Release Notes

Document No.: RN-251210-01
Date: December 10, 2025
Classification: External
Priority: Routine
Attn: All Customers
Related Products: C700
Subject: **C700 Firmware Release Note – V2.0.1**

1.4. Prevent incorrect DTMF detection causing unexpected temporary muting of voice calls.

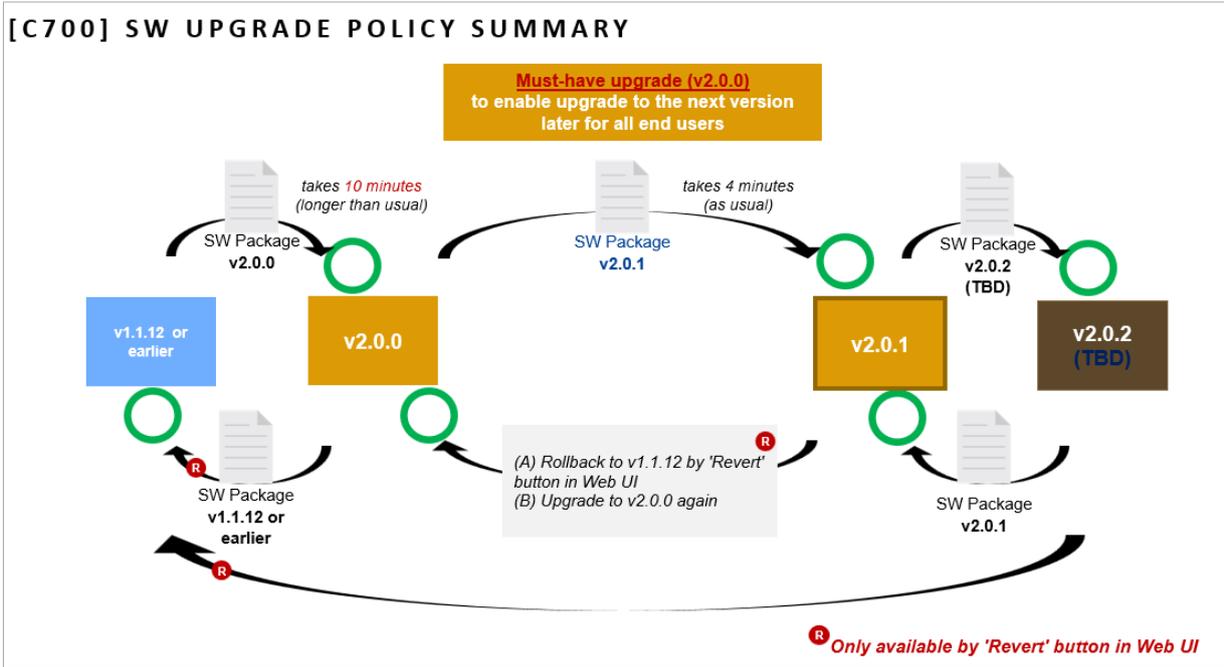
- This fixes an occasional issue where the terminal incorrectly detects DTMF tones on voice calls and then mutes the voice of the terminal user for up to 10 seconds.
